City of Santa Fe, New Mexico

memo

2026-012284-HDRB. 1062 Camino San Acacio, Downtown & Eastside Historic District, contributing, Gabriel Browne, agent/owner, proposes to replace windows and doors and install exterior insulation on the contributing structure. Construct a 3,440 sq. ft. freestanding residence to a height of 20'-9", where the maximum allowable is 16'-9". Construct a 733 sq. ft. guesthouse with a pitched roof and construct a 6'-0" high fence and a 4'-0" high yard wall. Additional height is requested due to slope per section 14-4.6(F)(2)(II)(f). Exceptions are requested to section 14-4.6(E)(4)(II) for placing a new architectural finish on a primary facade and for using material not in keeping with the district.

Figure 3: Primary Façade Diagram

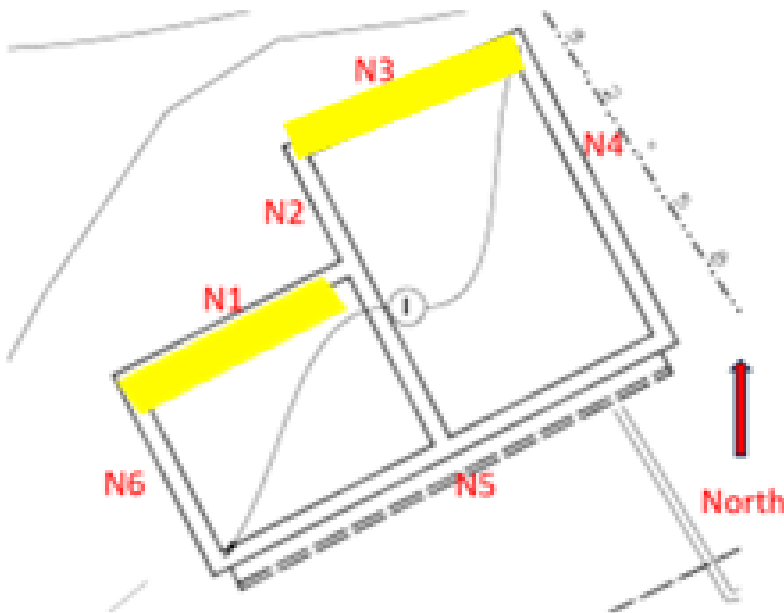
Staff Response: The staff finds that this criterion is not met. Placing exterior insulation on a building alters its appearance on the exterior. The insulation is a smooth surface with sharp corners. Adobe structures have soft corners and some irregularities on the surface of the building. To eliminate this feature for a smooth, even surface is to remove the unique character of the adobe building. This particular structure has a brick coping which is currently in line with the wall surface. Installing exterior foam will force the coping to no longer align with the building walls, affecting the appearance of the structure and therefore damaging the character of the district.

Staff Response: The staff finds that this criterion is not met. The applicant addresses water and rodent intrusion as reasons for insulation. This would not be the purpose of insulation. It is the purpose behind the work done under permit 2019-5288-EXTR as mentioned in the background section of this report. Moreover, the use of foam on adobe structures has caused issues with moisture and the structural stability of the adobe.
